From: J Sevilla [qmakeda@chesapeake.net]
Sent: Friday, July 09, 2010 3:58 PM
To: CalvertCliffsCOLAEIS Resource; Quinn, Laura; woody.francis@USACE.ARMY.MIL; Steckel, James; Arora, Surinder
Cc: Peter Saar; Peter Vogt; Michael Mariotte; Allison Fisher; Paul Gunter; Bruce Gordon; Chris Bush; William Johnston; fabiada@yahoo.com; Timothy Flaherty; harold thornburg
Subject: June Sevilla submission to DEIS (DRAFT NUREG 1936) and FSAR - #1 of 3 emails
Attachments: June 26 2010 ltr-Kidwell-Sevilla-FSAR Rev 6 analysis.pdf
Importance: High

Subject: June Sevilla submission to DEIS (DRAFT NUREG 1936) and FSAR - #1 of 3 emails
Sent Date: 7/9/2010 3:58:10 PM
Received Date: 7/9/2010 4:05:22 PM
From: J Sevilla

RE: Comments on CCNPP Unit 3 FSAR Rev 6 Section 2.5 “Geology, Seismology, and Geotechnical Engineering”

Encl 1 – Gernant's Fig 4, page 10 of 1970 Maryland Geological Survey,
Report of Investigations No. 12:

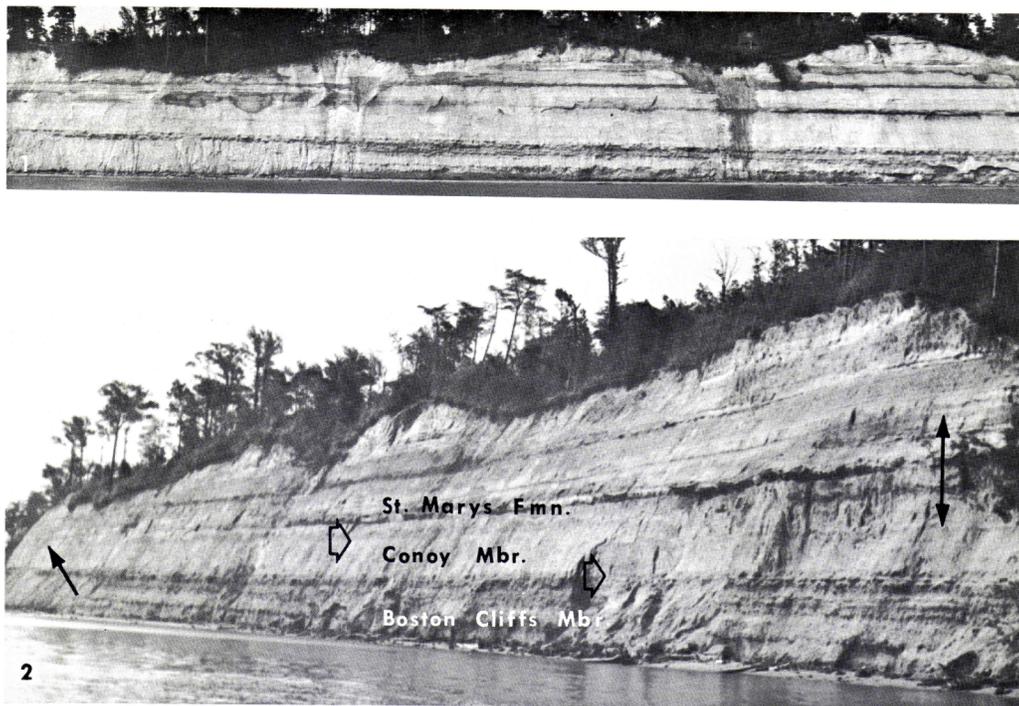
Concerning the apparent lack of other published observations on structural warping (p. 2-1118), Gernant (1970, Maryland Geological Survey, Report of Investigations No. 12) also detected the notable change in dip of Miocene strata within the Conoy Cliffs and also attributed it to folding (see Encl 1: Gernant’s Figure 4, p.10, included below). This is one published paper missed in the FSAR review, albeit directly relevant. [The one outcrop photograph provided in the FSAR (Fig. 2.5-44) is a highly oblique view of the same Conoy Cliffs, taken from a large distance, that will minimize the viewers ability to appreciate the feature. It concerns me that this might have been the only perspective FSAR authors had, other than perhaps a highly foreshortened view from the narrow beach at the base of the Conoy Cliffs.] Genant and I both recognized the involvement of folding in the creation of the reversed dip of Choptank Formation beds within the Conoy Cliffs, despite the erosional nature of the stratigraphic discontinuity surface(s) that define those beds. (Paleo)erosion is commonly localized in areas of relative uplift (regardless of whether uplift is antecedent/inherited, syn-depositional, or post-depositional). The erosional nature of some of the bed contacts that Gernant and I traced is thus not mutually exclusive with the existence of structural warping as a contributing – or even a primary – control on observed changes in bed elevation, contrary to the implication of the FSAR (e.g.. p. 2-1095, “undulations typically represent erosional features...”). My 1997 paper is explicit that, although some variation in elevation of beds (more precisely, discontinuity surfaces) within the larger Calvert Cliffs are entirely erosional in nature (representing incised channels), changes in elevation near the CCNPP and some others appear to instead be structural warps, at least in part (1997 JSR paper, p. 324). That assessment reflects an explicit rejection of the hypothesis of erosion. In fact the lack of any sedimentary response to the relative (paleo)high on the south side of Moran Landing– St Marys beds do not thin or become coarser over it -- argues that the offset in elevation here is post-depositional (notice the continuity of facies tracts within SM units that can be traced across the postulated fault plane in my 1997 cross-section). The FSAR authors seem to be broadly skeptical of changes in bed elevation as evidence of structural features (e.g., in also rejecting McCartan and others’ postulated monoclines, p. 2-1093, -1095, -1116, -1199, etc.) and to be unattuned to using sedimentologic/ stratigraphic evidence for growth faulting and folding. I, too, would not use it as definitive evidence. However, I would expect an explicit testing of faults hypothesized on this basis using more definitive methods (dedicated boreholes, trenches, seismic profiling) before rejecting it, especially when placement of a public facility was an issue.

Encl 2a – Sevilla Exhibit # 4, PSC CPCN Case No. 9218 testimony – Kidwell:

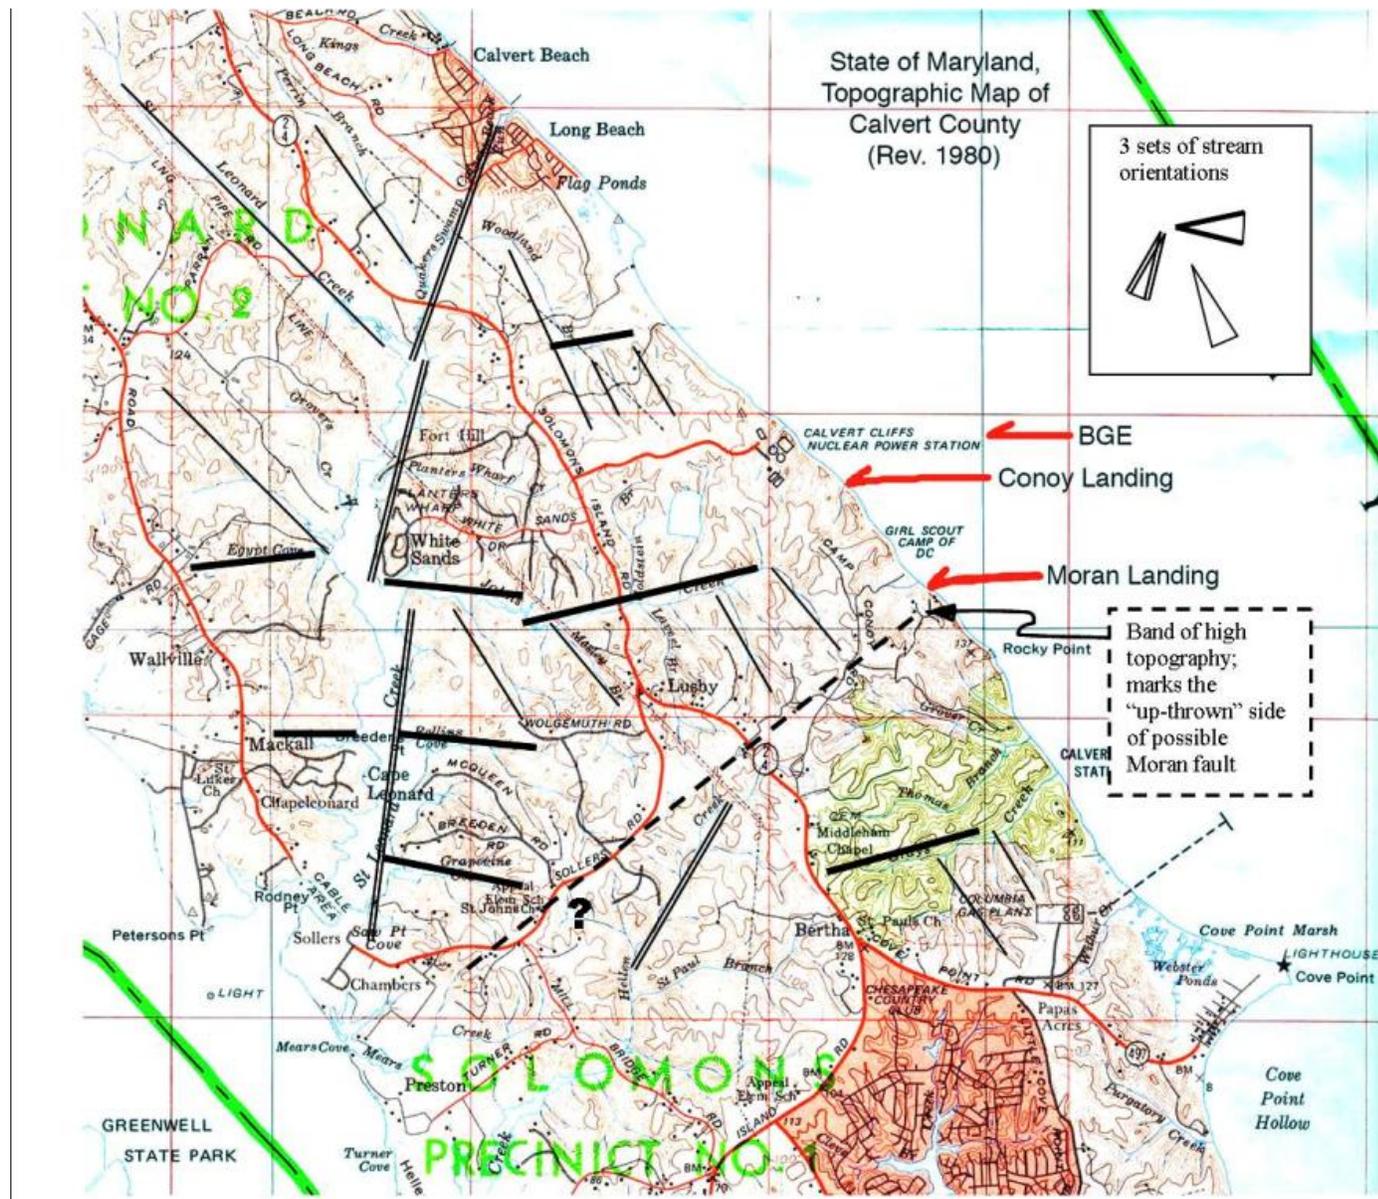
1. Many streams have suspiciously long straight stretches and make approximately right-angled turns, which is typical of terrains where there is an underlying structural (tectonic) control on drainage.
2. This contrasts with the "dendritic" (root-like) pattern that typifies terrains lacking any structural control on the weakness of the underlying rocks.

3. Tenured and experienced geologists Dr. Susan Kidwell, Dr. Peter Vogt, and Dr. Curt Larsen concur that in this part of Calvert County there is
 - a. a set of stream segments with a basically East-West orientation (indicated by bold solid lines on map; for example, Johns Creek, which heads east toward the southern end of CCNPP property),

- b. a second set of stream segments having a South-Southwest orientation (doubled-lines; for example, St Leonard Creek and its overland extension to Long Beach), and

- c. a third set of mostly minor streams having a South-Southeast orientation (many fine solid lines).
4. The “overlaid stream line segments” on the topographical map have been positioned slightly east or north of the relevant stream so as not to obscure the trace of the stream on the map or the labels providing the stream names.

5. The bold dashed line on the map, running Northeast - Southwest, marks a band of topographically high land that extends from the Calvert Cliffs over to the Patuxent River:

- a. It begins under the Moran property and
 - b. coincides with Sollers Road for a considerable stretch and in the direction of the mouth of Mears Cove on the Patuxent River.

- c. This dashed line does not mark the trace of the postulated Moran Fault, but rather the topographic high running land along the edge of the "up-thrown" block. The fault line would be located on the north side of this dashed line within the order of a quarter mile.

6. The location of the CCNPP Unit 3 Cooling Tower, when measured relative to the dashed line is about a half mile northwest of the dashed line; even lying closer to the postulated Moran Landing Fault (less than a half mile).
